TECHNICAL MEMORANDUM

Date: August 23, 2020
To: Alaska Department of Environmental Conservation, Division of Water
From: André Sobolewski, Clear Coast Consulting, Inc
Subject: Review of water treatment plants proposed in FEIS for Pebble Project

Figure 1. Water Treatment Plant #2 - Operations Phase. Taken from USACoE FEIS Appendix N – Project Description

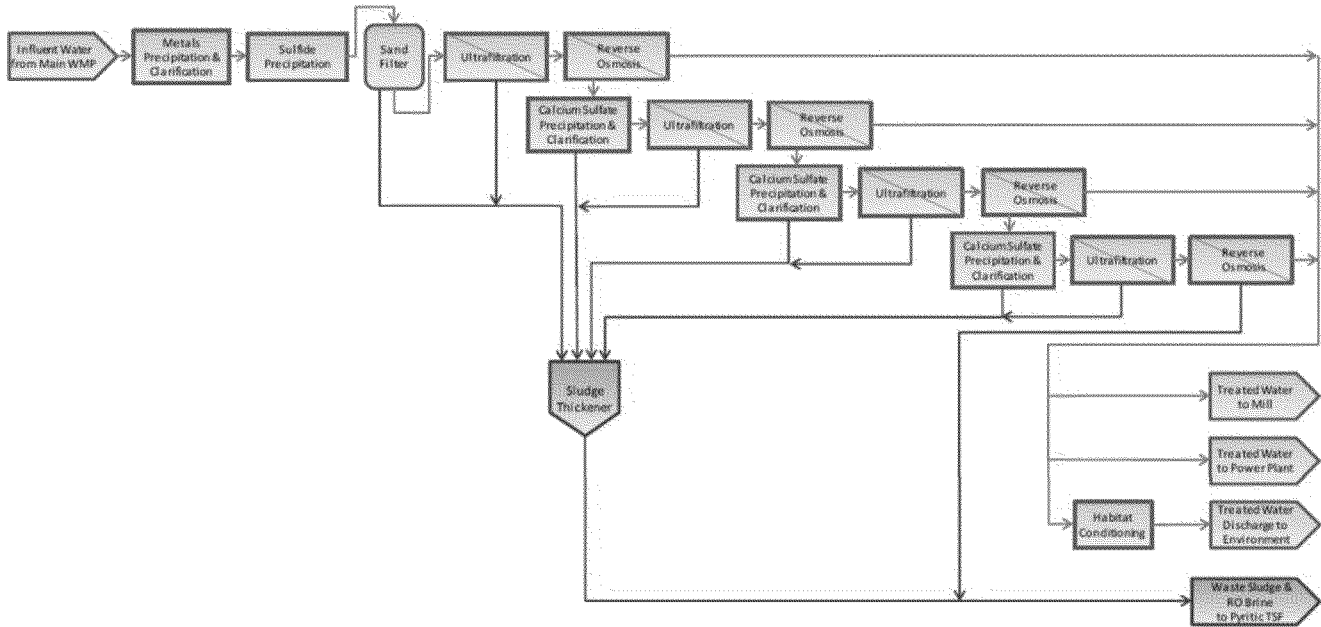
For this analysis, I used the proposed WTP #2 for mine operations (Figure 1), as it is among the most comprehensive WTP proposed for this project (WTP #3 also comprises an evaporator/crystallizer unit). This treatment system shares many components with WTP #1 and WTP #3 and any analysis of WTP #2 will readily apply to these other treatment plants.

The first step in the treatment process – permanganate oxidation and ferrihydrite precipitation – is effective in removing arsenic and manganese and is widely used. Depending on treatment conditions (pH, ORP), molybdenum will also be removed to acceptable levels, as demonstrated in the treatment plants at the closed Brenda Mine (Aubé and Stroiazzo, 2000) and at Coldelco's El Teniente Mine (Aubé and Vergara, 2010).

A contractor for the Pebble Limited Partnership (PLP) reported that permanganate oxidation, followed by ferrihydrite precipitation will remove selenium (RFI 021e Addendum, 2019), but this process is wrong. Ferrihydrite will precipitate the *partially-reduced* selenite (SeO_3^{2-}), not the *full oxidized* selenate (SeO_4^{2-}). Thus, an initial oxidative step is inappropriate because a chemical reduction of unreactive selenate to selenite is required, such as by addition of zinc dust (Alberta Environment, 2005). The subsequent ferrihydrite precipitation will decrease inflow concentrations of selenium to ~0.020 mg/L. An additional step is necessary to decrease its concentration < 0.005 mg/L.

Selenium is proposed to be removed as a selenide via precipitation with sulfide. This reaction is technically possible, but it requires conditions that are not met in a mining environment (low redox potential, high sulfide concentrations, etc). To my knowledge, this process has never been used in a commercial application, and certainly never at a large-scale mining operation. Several specialists who know or investigated this process¹ have confirmed that sulfide precipitation is impractical and has never been used for selenium removal from mine water.
